Access Compliance Report

Public Rights-of-Way

(Curb Ramps)

Intersection ID: 3984	Main Street: GENOA_LN	Cross Street: HALLIWELL_ST	Location: S
ADA ID: 2F4702FD897F	Ramp Type: Perp	Initial Pass/Fail: Fail	Overall Compliance: No
		Severity Score: 25

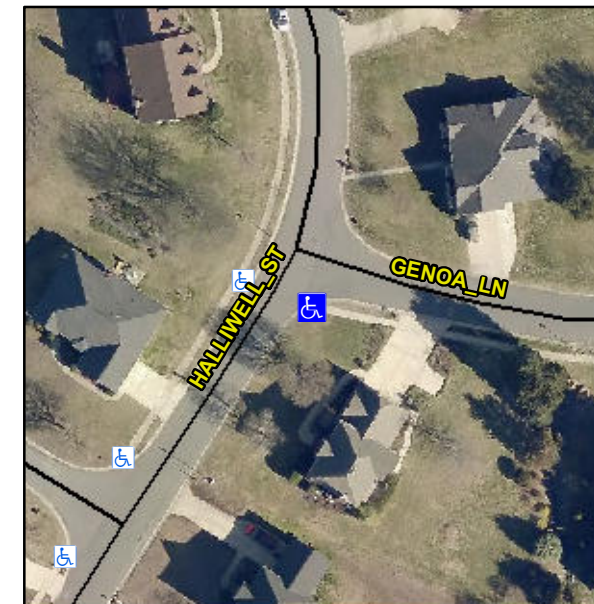
Not Found, R304.5.3

Compliance	Description	Data	Compliance	Description	Data
N/A	Ramp Length (in)	42.0	Yes	Ramp Slope (%)	7.3
Yes	Ramp Width (in)	48.0	No	Ramp XSlope (%)	11.4
N/A	Flare Type LT	N/A	N/A	Flare Type RT	N/A
N/A	Flare Slope LT (%)	N/A	N/A	Flare Slope RT (%)	N/A
N/A	Flare Traversable LT?	N/A	N/A	Flare Traversable RT?	N/A
N/A	Landing Length (in)	N/A	N/A	DWS Provided?	N/A
N/A	Landing Width (in)	N/A	N/A	DWS Contrast?	N/A
N/A	Landing Slope (%)	N/A	N/A	DWS Length (in)	N/A
N/A	Landing X Slope (%)	N/A	N/A	DWS Full Width?	N/A
N/A	Landing Curb? (Y/N)	N/A	N/A	DWS Offset (in)	N/A
N/A	Shared Landing?	N/A			
N/A	Gutter Ponding?	N/A	N/A	Gutter Slope (%)	N/A
N/A	Gutter Lip Ht (in)	N/A	N/A	Gutter X Slope (%)	N/A
N/A	Painted X Walk1?	No	N/A	Painted X Walk2?	N/A
	X Walk 1 Direction	To NW		X Walk 2 Direction	N/A
N/A	X Walk 1 Width (in)	N/A	N/A	X Walk 2 Width (in)	N/A
	X Walk 1 Slope (%)	8.7		X Walk 2 Slope (%)	N/A
	X Walk 1 X Slope (%)	7.1		X Walk 2 X Slope (%)	N/A

Remove & Replace Entire Ramp.
